## **DISCUSSION of:**

# **Ground Improvement Using Preloading with Prefabricated Vertical Drains**

**Full Reference:** Dhar, A.S., Siddique, A., Ameen, S.F., (2011). Ground Improvement using Pre-loading with Prefabricated Vertical Drains. International Journal of Geoengineering Case Histories, <http://casehistories.geoengineer.org>, Vol.2, Issue 2, p.86-104. doi: 10.4417/IJGCH-02-02-01.

**Bengt H. Fellenius, Dr. Tech., P.Eng., Canada; email: [bengt@fellenius.net](mailto:bengt@fellenius.net)**

Figure 1. Settlement measured at the benchmarks shifted 10 days.

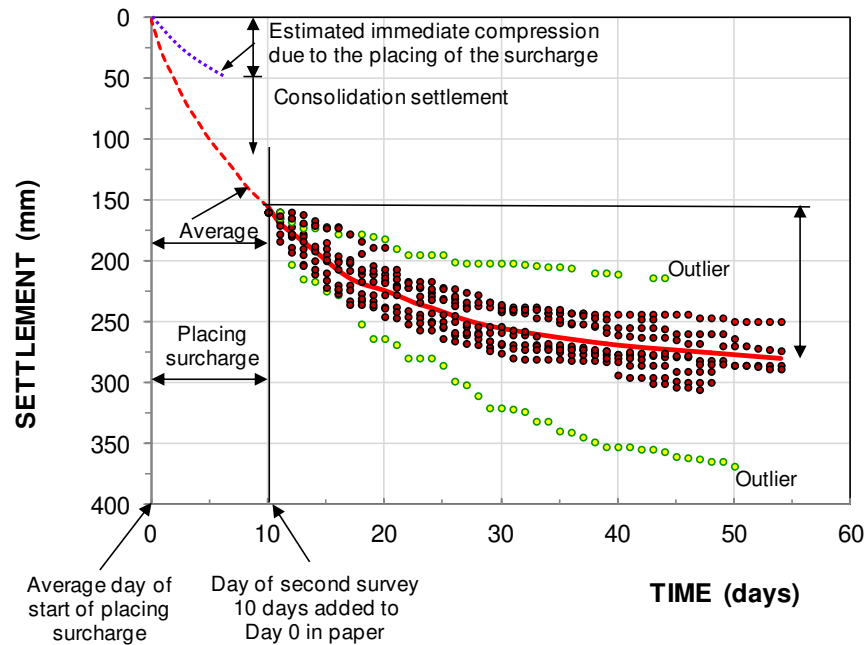
The authors report, that the first survey of the benchmarks was taken before the 3.0-m surcharge was placed across the test area. The first day of settlement measurements for the twelve benchmarks was the date of the second benchmark survey, which was carried out only when all of the surcharge had been placed to the full height over the test area. The time between the first and second surveys—and the placing of the surcharge—ranged from a few days to twenty days. Because the times between the placing of the surcharge and the second survey differed for the benchmarks, the amount of settlement that had occurred at the time of the second survey also differed between the benchmarks. This explains some of the significant scatter displayed in the authors' Figure 13. I have re-plotted the measured settlements in Figure 1 to a common starting point at the average start settlement of 160mm and added 10 days to the authors' measurement days to indicate the average duration of placing the surcharge, which took place before the second survey. During this time, immediate compression and some consolidation will have occurred. As indicated, I estimate the immediate compression to be about 50 mm. I have also added an average curve and extrapolated it back to the origin (the average excludes the two outlier records). All benchmarks appear to show that most of the consolidation had developed at the time the last survey was made.

Figure 2. Settlement measured at the benchmarks normalized to the average end values.

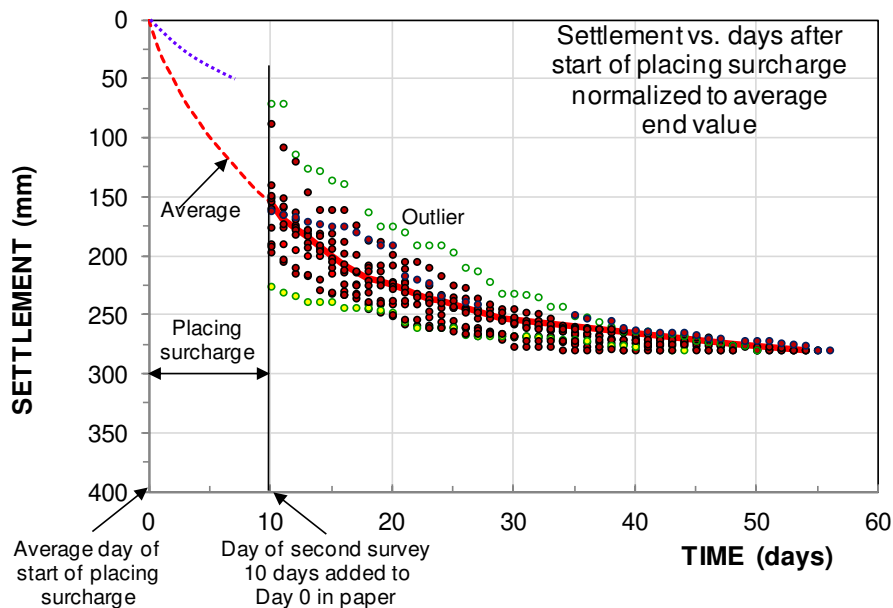
Figure 2 shows the measured final settlements are normalized to the average final settlement (280 mm). There is still much scatter between the curves, but now the approximate start date for each curve can be obtained by sliding the curves left or right until the best agreement to the average curve is obtained as shown in Figure 3. The removal of much of the scatter—the agreement between the time-settlement curves—is of course to some extent fictitious as the benchmark measurements cannot be expected to be all that similar; a natural variation must have taken place, not least with regard to the thickness of the soft clay layer. However, I believe that the figure suggests a reasonably realistic day for the start of placing the surcharge.

Figure 3. Settlement measured at the benchmarks adjusted to obtain the approximate start day.

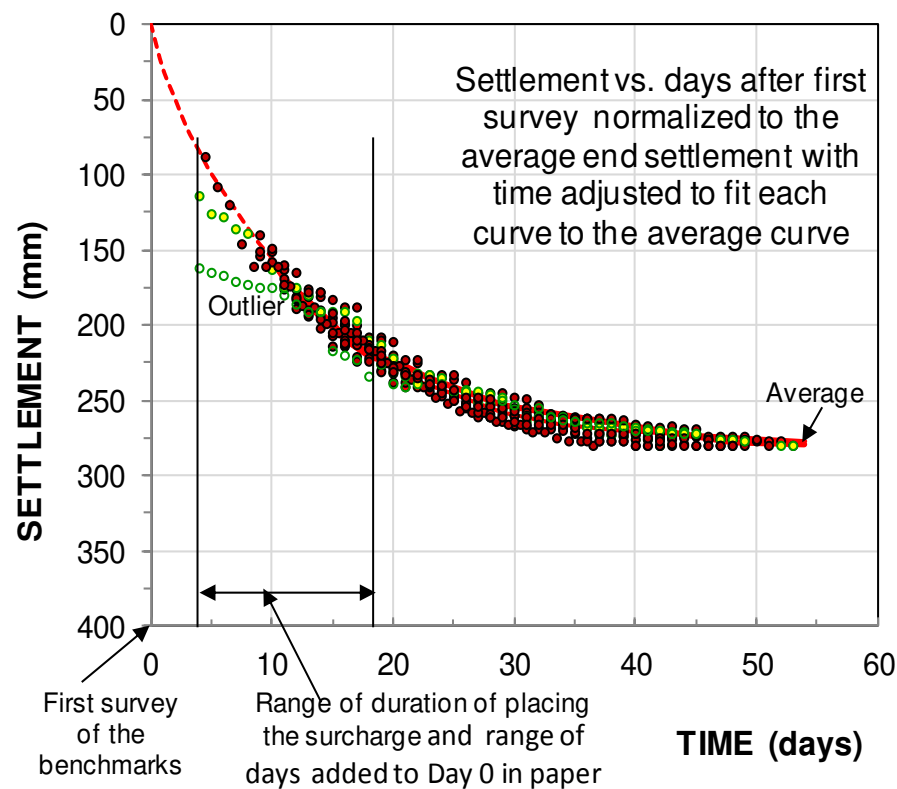
The average curve shown in Figure 3 can now serve as reference to a back-calculation of the time-settlement development for the wick-drain project to determine compressibility and coefficient of consolidation of the soil layers. The back-calculation consists of applying the theory of pore pressure dissipation in fine-grained soils (consolidation) due to radial flow (Barron 1948, Kjellman 1948, and Hansbo 1960; 1979) is based on radial flow toward a circular drain in the center of a cylinder of homogeneous soil with an impervious outer boundary surface). The theory is summarized in the Kjellman-Barron formula, Equation 1. The Kjellman-Barron formula is based on the assumption of horizontal (radial) flow only and a homogeneous soil.

Figure 4. Average measured and calculated settlements.

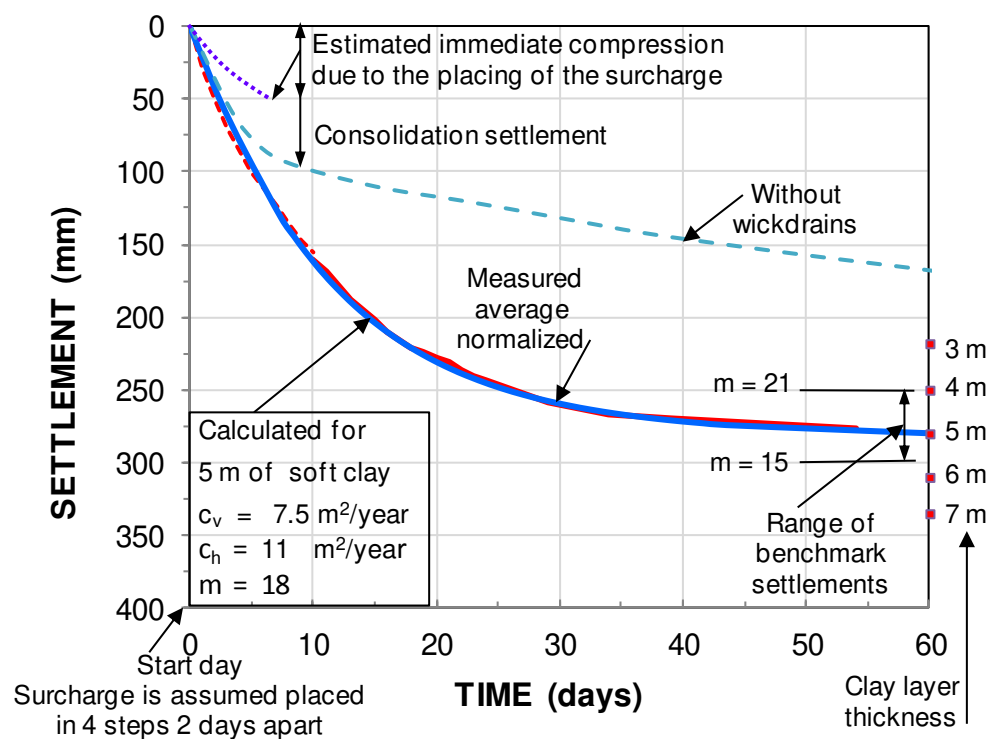
The results of the back calculation are shown in Figure 4 together with the average curve of the measurements. In order to show the sensitivity of the clay layer thickness and modulus number, the figure also shows the final settlement for soil layer thickness ranging from 3 through 7m and the final settlement resulting from modulus numbers of 15 and 21. The figure also shows the settlement during the first 60 days that would have occurred had there been no wick drains (for this input, I used the authors' 7.5m<sup>2</sup>/year  $c_v$ -coefficient).

Considering that my data reduction is quite different to that of the authors, my back-calculated  $c_h$ -coefficient (11m<sup>2</sup>/year) agrees well with the authors' laboratory-established value (14m<sup>2</sup>/year). The difference could be taken to represent the effect of a smear zone. However, considering all the uncertainties involved, I believe the agreement to be entirely fortuitous.
